# **Kirknewton Visual Reference Point (VRP) change**

## **Airspace Change Proposal Document**

**OTH-2025-003**

Owned by	MATC Edinburgh
Authored by	Innovation Lead
ANSL Reference	CR-ANS-2180

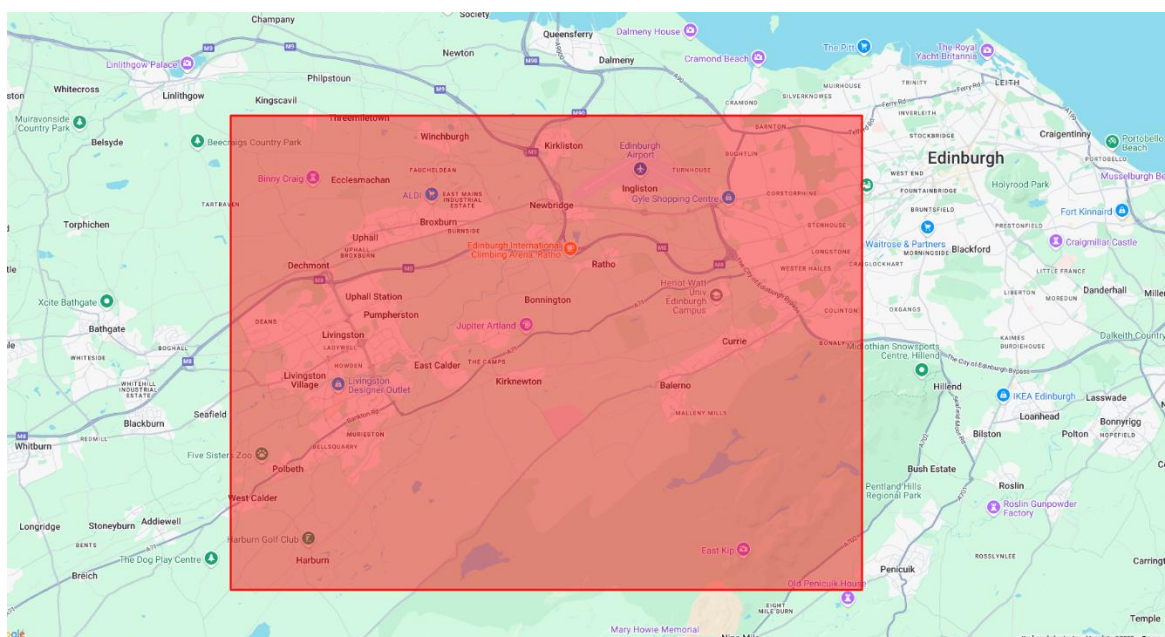
The proposed Kirknewton Railway Station VRP is at 555319.74N 0032601.54W. Both the existing and new VRP are positioned in the Edinburgh CTR. Details about the change from the current to new VRP reference are shown in the image below (the current VRP is in green):

The objective of the change is to replace the existing VRP with a new one at KIRKNEWTON RAILWAY STATION. The new VRP is situated approximately 0.5nm to the WNW of the existing one.
